VIRGINIA ELECTRIC AND POWER COMPANY
SURRY POWER STATION UNIT 1
ASME SECTION XI INSERVICE INSPECTION PROGRAM
PARTIAL EXAMINATION RELIEF REQUESTS
RESPONSE TO REQUEST FOR ADDITIONAL INFORMATION

Response to NRC Request for Additional Information

Relief Request No. PRT-05 Revision 1

Figure 1

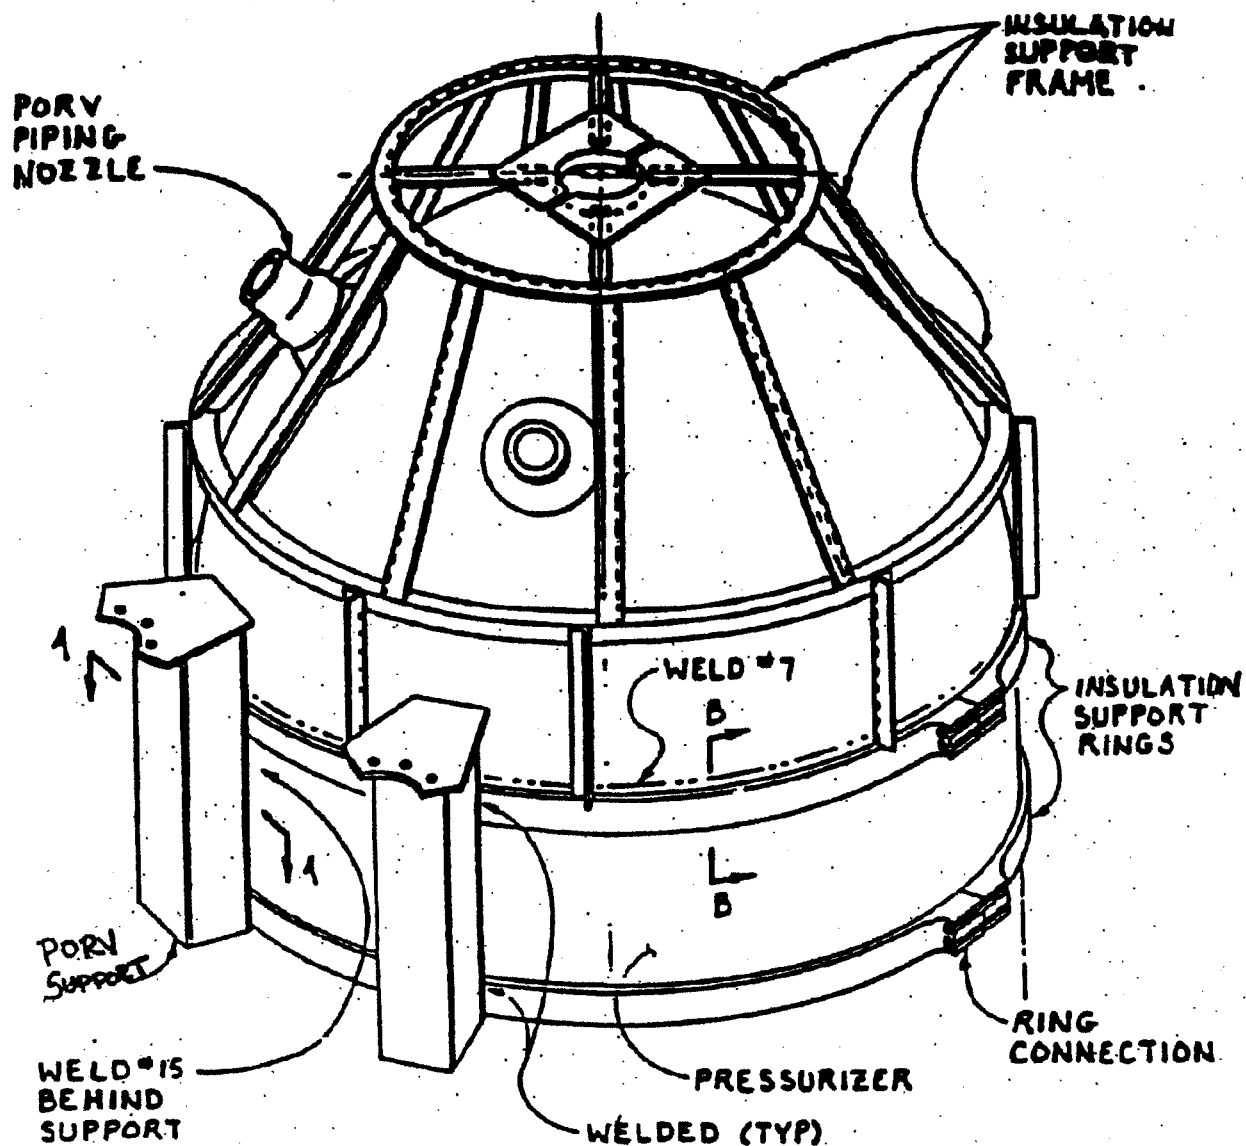
- a. The licensee provided, as Figure 1, a sketch showing how the pressurizer insulation support ring and the power-operated relief valve (PORV) welded support restrict access to make scans on Welds 1-07 and 1-15. This sketch adequately explains the limited access to examine the shell-to-head and intersecting longitudinal weld from the shell side. Also, the licensee provided the tables to indicate completed volumetric percentages for each of the scans on each weld. For example:

The pressurizer is covered with an insulation support ring (Figure 1). The insulation support ring is 6 inches wide at the location where examination interference is encountered for weld 1-07. As seen in Figure 1, this insulation support ring and a power operated relief valve support prevent the required volumetric coverage of both the upper circumferential head weld 1-07 and the intersecting longitudinal weld 1-15. Total removal of the insulation support ring at the mechanical connection is considered impractical due to high anticipated exposure levels, estimated at 18 man-rem. Partial removal of the support ring could allow some increased

Figure 2

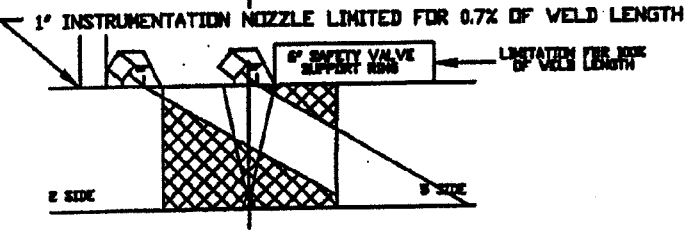
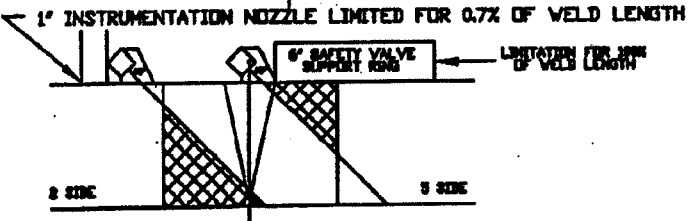
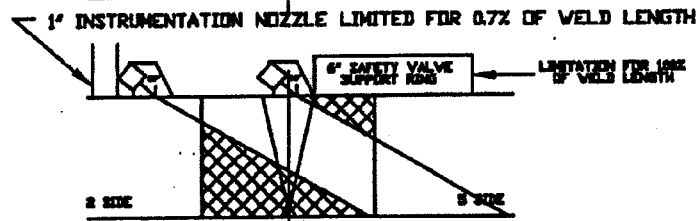
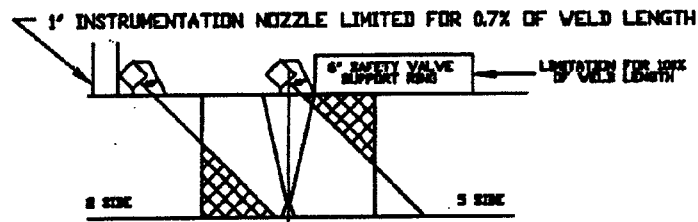
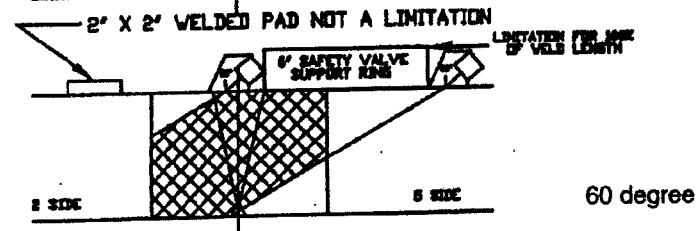
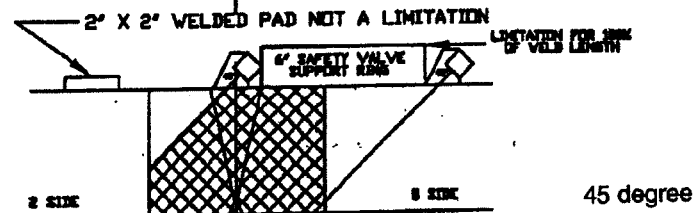
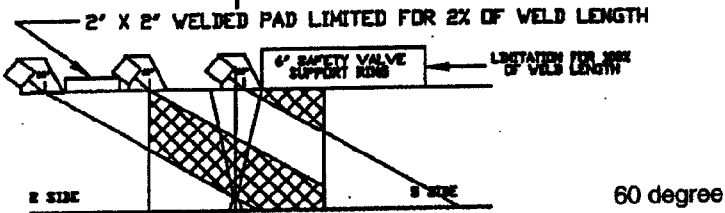
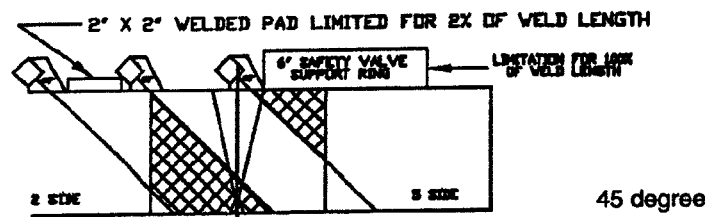
- b. In addition, no explanation to describe the information in Figures 2 or 3 is given in the licensee's request. These appear to be cross-sectional drawings that depict volumetric coverage of Welds 1-07 and 1-15, respectively. The interferences shown in Figure 2 are labeled 2 x 2-inch welded pad, 1-inch instrumentation nozzle, and 6-inch safety valve support ring. Please explain whether these interferences impact the full length of Weld 1-07 or only near the PORV. Also, indicate which scans are directly affected by these interferences, and what portion of the entire length of the scan is impacted.

Figure 2 shows obstructions for weld 1-07 in the 2 and 5 directions using both 45 and 60 degree angle beams. The 2 direction was limited as shown by the safety valve support ring for the entire length of the weld. The 2" X 2" welded pad (typical of three) reduced the weld inspection as shown for 2% of the total weld length in the 2 direction. Also the instrument nozzles (typical of four) limited the 2 direction for 0.7% of the total weld length as shown for 45 and 60 degree angle beams. The 5 direction scan was limited by the safety valve support ring for the entire length of the weld. Total percentage covered is determined by calculating the cross sectional area not examined, multiplying by the percent limitation for the entire weld length attributed to that obstruction and subtracting from 100% coverage.
